The Commission has issued the enclosed Amendment No. 33 to Facility Operating License No. NPF-2 and Amendment No. 26 to NPF-8 for the Joseph M. Farley Nuclear Plant, Unit Nos. 1 and 2, respectively. The amendments consist of changes to the Technical Specifications in response to your application transmitted by letter dated November 16, 1982 supplemented by letters dated February 1, 1983 and June 29, 1983.

Amendment No. 33  
License No. NPF-2

Amendment No.26  
License No. NPF-8

SAFETY EVALUATION BY THE OFFICE OF NUCLEAR REACTOR REGULATION  
RELATED TO AMENDMENT NO.33 TO FACILITY OPERATING LICENSE NO. NPF-2  
AND NO.26 FACILITY OPERATING LICENSE NO. NPF-8  
ALABAMA POWER COMPANY  
JOSEPH M. FARLEY NUCLEAR PLANT UNIT NOS. 1 AND 2  
DOCKET NOS. 50-348 AND 50-364

FIGURE 6.2-2 FACILITY ORGANIZATION

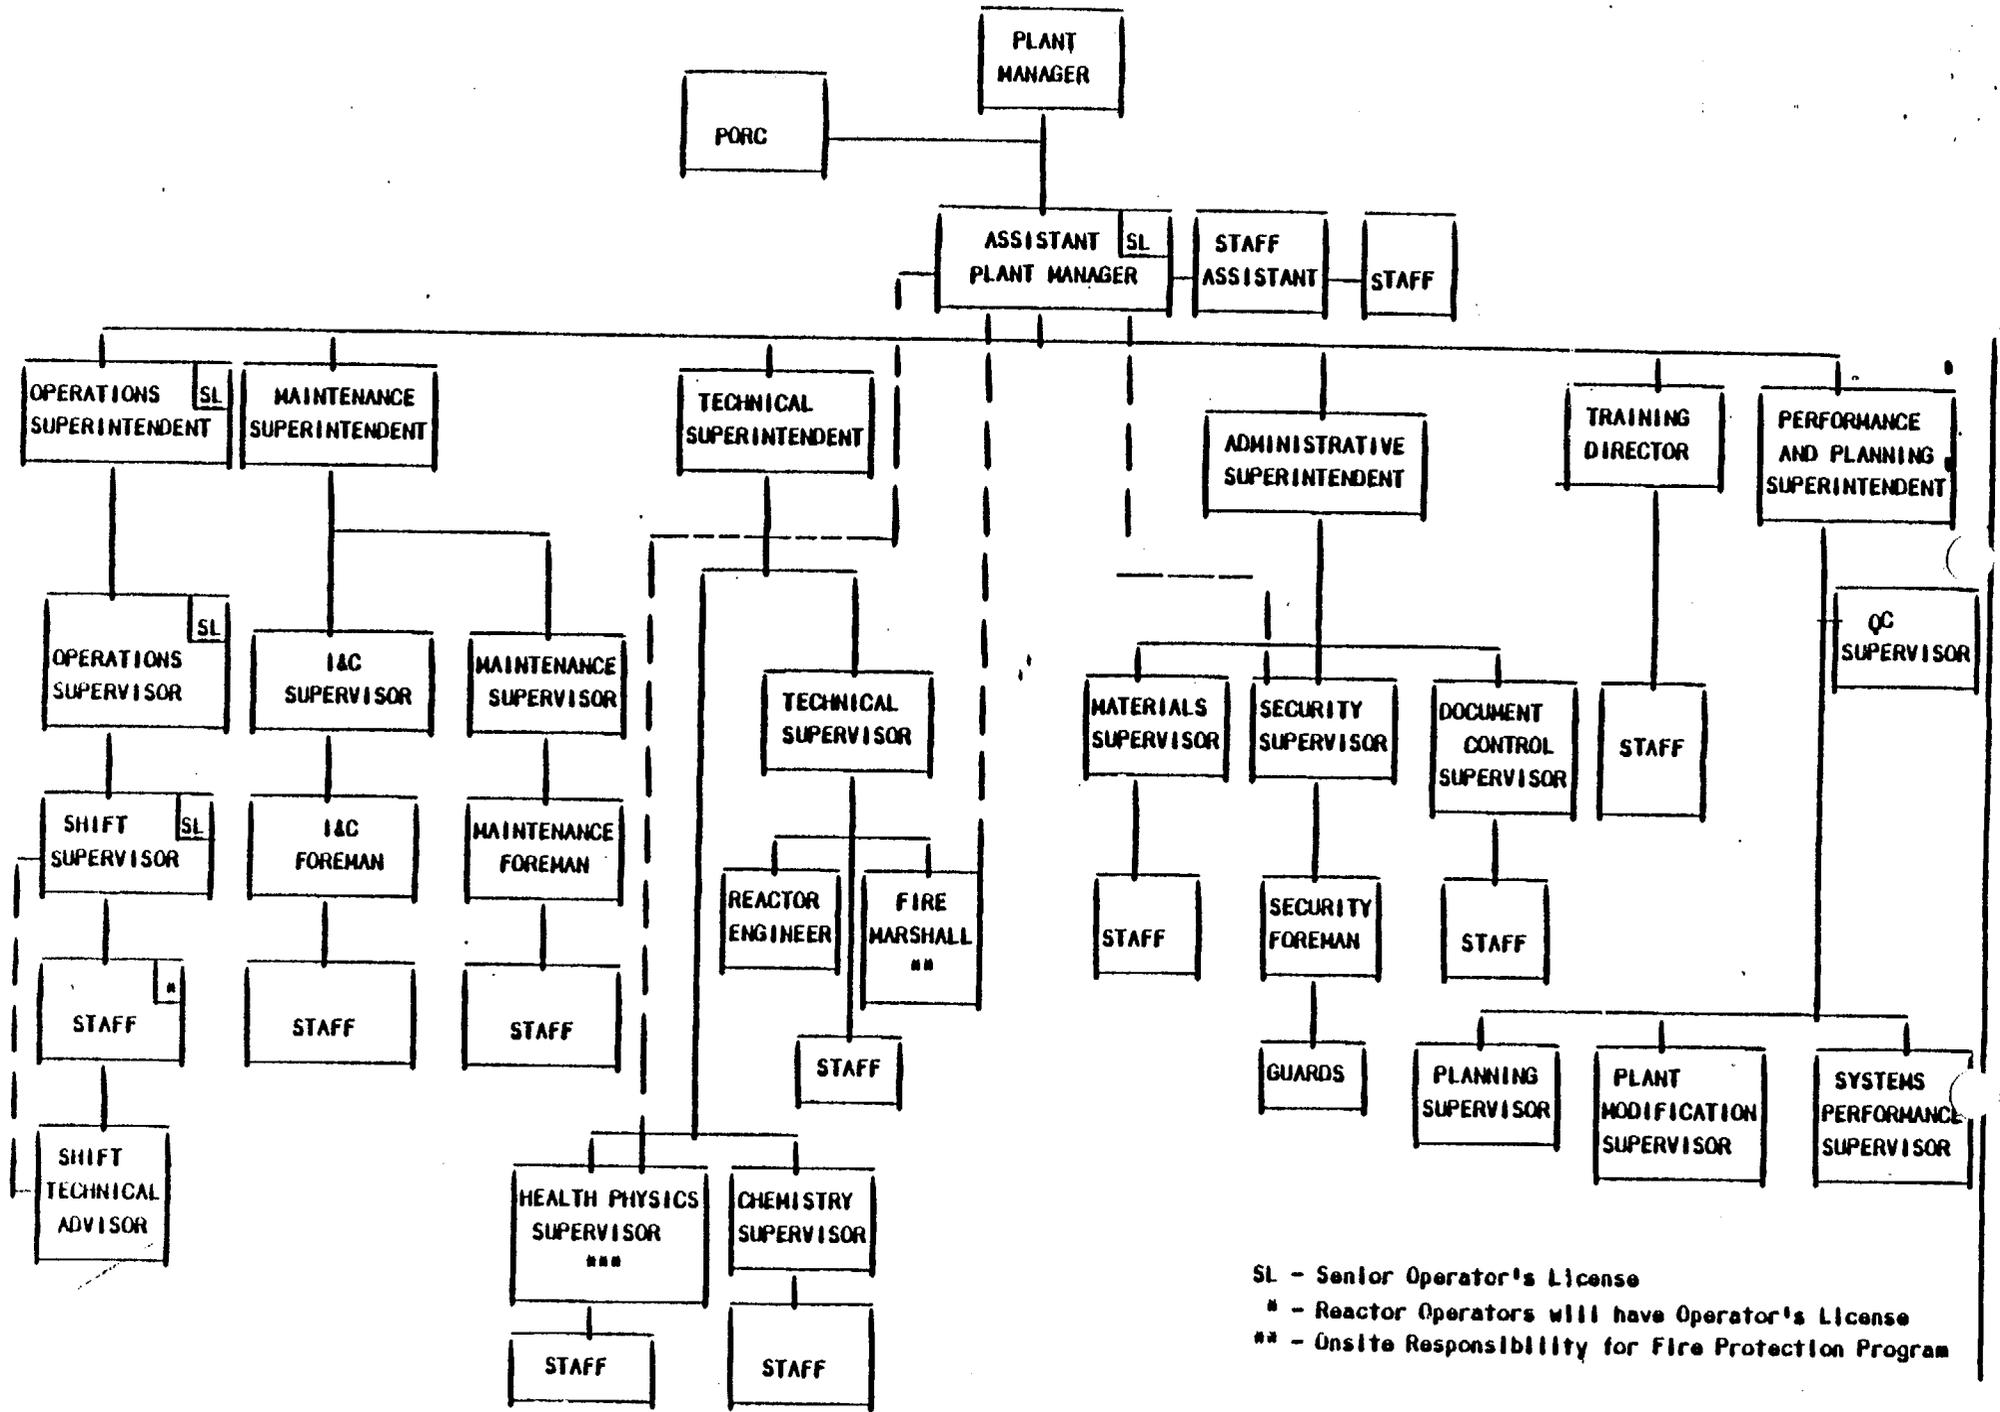
In their letter of February 1, 1983, APCO proposed for each unit changes to Figure 6.2-2, the onsite "Facility Organization" chart, to reflect the addition of a Quality Control Supervisor and a Plant Modifications Supervisor. In their

letter of August 23, 1983, APCO proposed additional changes to Figure 6.2-2, and a change to Technical Specification 6.3.1, which specifies minimum facility staff qualifications. These changes are to reflect APCO's having created two positions, the Health Physics Supervisor and the Chemistry Supervisor, from a former position which combined the two roles. The proposed chart reflects that the Health Physics Supervisor reports to the Technical Superintendent except for in matters of radiation policy, where he/she reports to the Assistant Plant Manager. APCO reported one other change to Figure 6.2-2, this to show the change of the title of the Training Supervisor to "Training Director".

The reorganizational changes that allow the Plant Manager to report directly to the corporate officer responsible for the facility will not diminish plant supervision. No minimum job qualifications specified in the FSAR were lessened in the reorganization and addition of personnel; the personnel additions would in fact allow for an increase in the supervision of the facility. All of the changes proposed to the Administrative Controls Technical Specifications are administrative, and are necessary in order to reflect the present facility personnel organization.
